**PRE-REMEDIAL DESIGN  
FIELD INVESTIGATION  
SUBUNIT B/C  
PHOENIX-GOODYEAR AIRPORT  
SUPERFUND SITE  
GOODYEAR, ARIZONA**

**Revised April 3, 1992**

Subject: Responses to Comments  
Phoenix-Goodyear Airport Superfund Site (south)  
Final Remedy Consent Decree, No. 88-1442 PHX EHC  
Subunit B/C Field Investigation Work Plan, Goodyear, Arizona

**FIGURE 3.4 GROUND WATER CHEMISTRY  
TOTAL DISSOLVED SOLIDS COMPARISON  
SUBUNIT A VS SUBUNIT C**

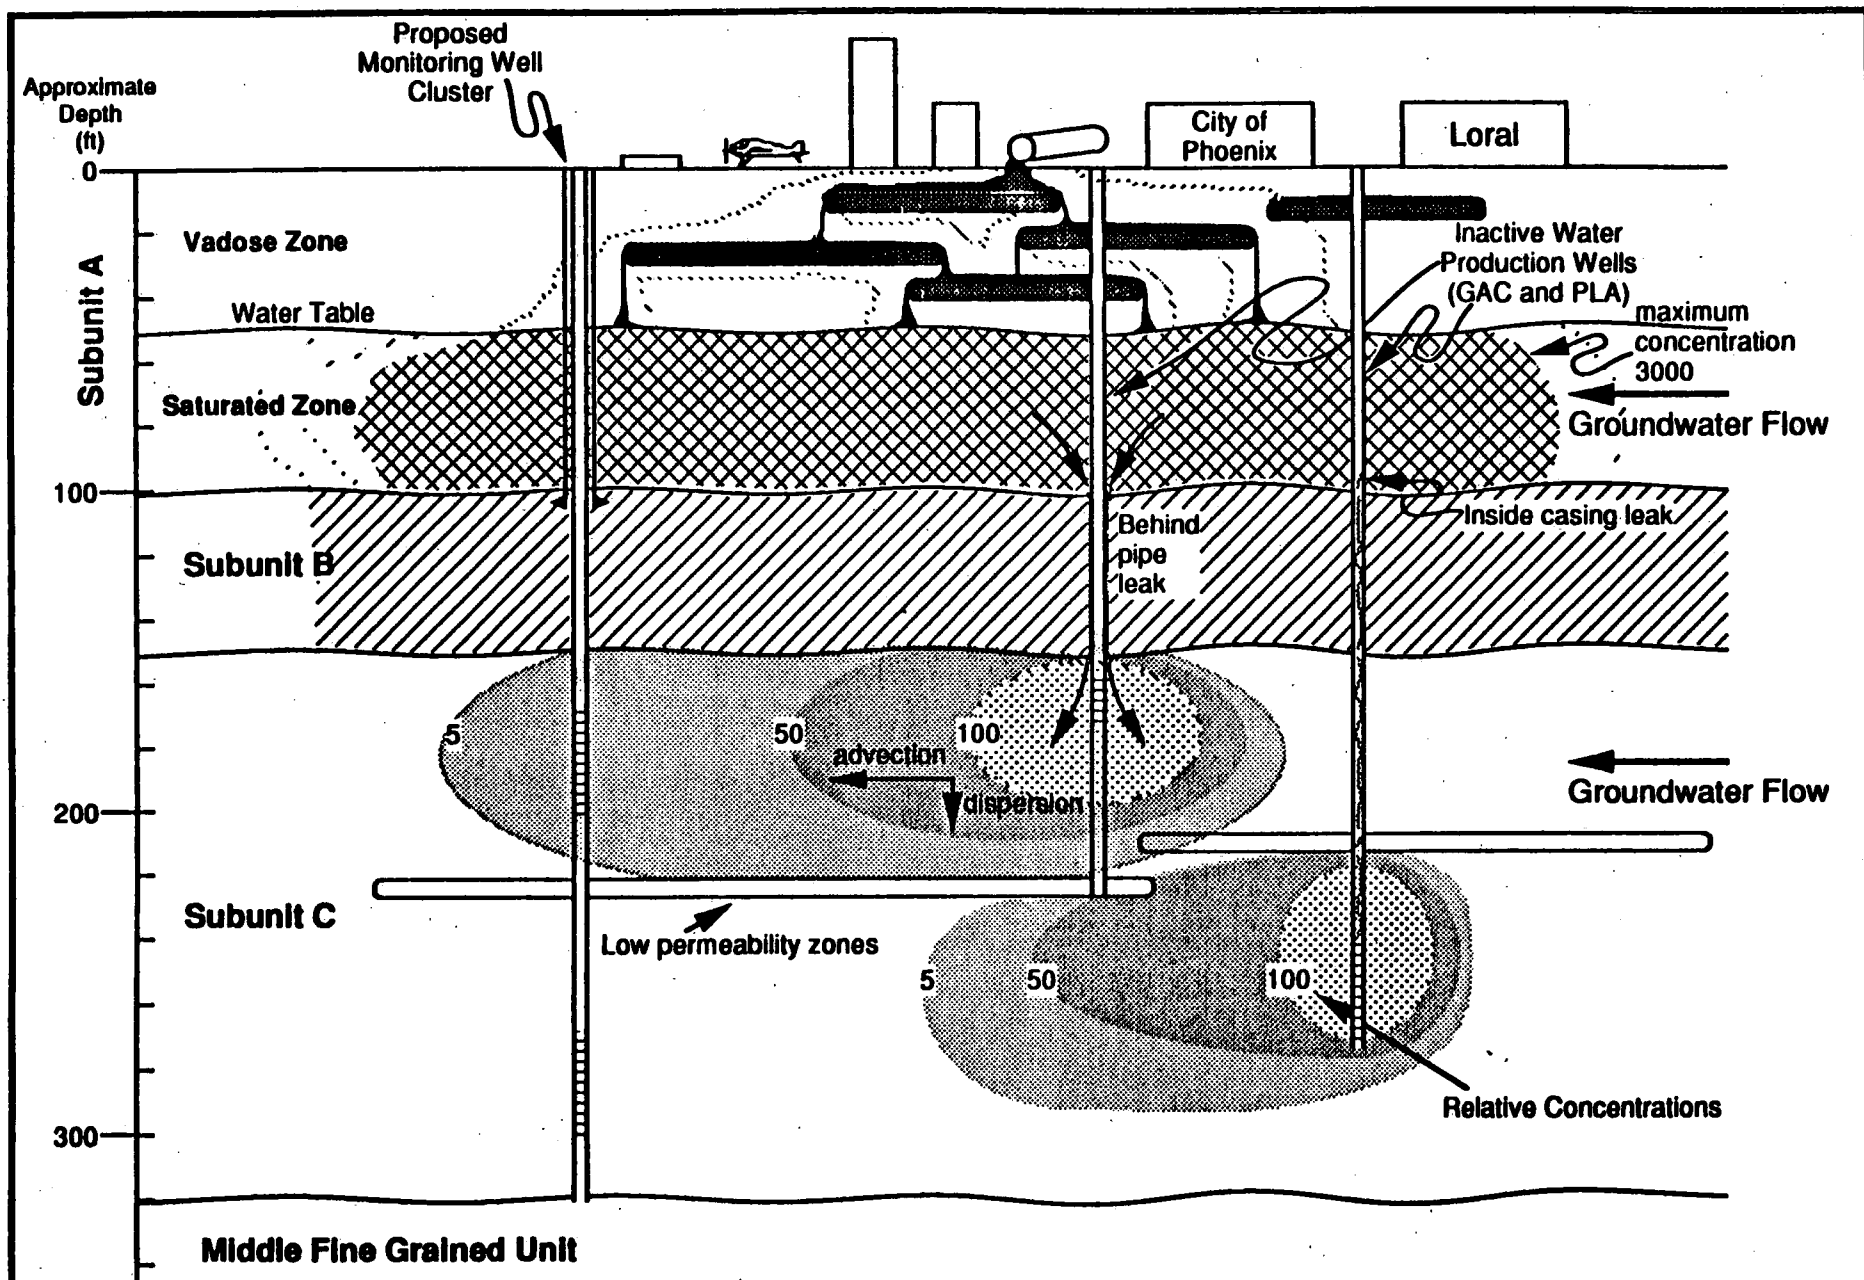
**Comment:** Although EPA agrees with Goodyear's interpretation that current data indicates that the Phillips well and RECMET2 yield water more like Subunit A than Subunit C, the requirements of Section VII.C.2. of the Consent Decree regarding well-head treatment requirements still apply to these two wells. Furthermore, in order to gather more information confirming that the contamination in RECMET2 and Phillips wells are localized at each well, Goodyear may wish to consider gathering additional groundwater quality data between the Subunit A Treatment System injection field and the Phillips well.

*One multi  
comp  
well  
between  
injection  
field  
&  
Phillips*
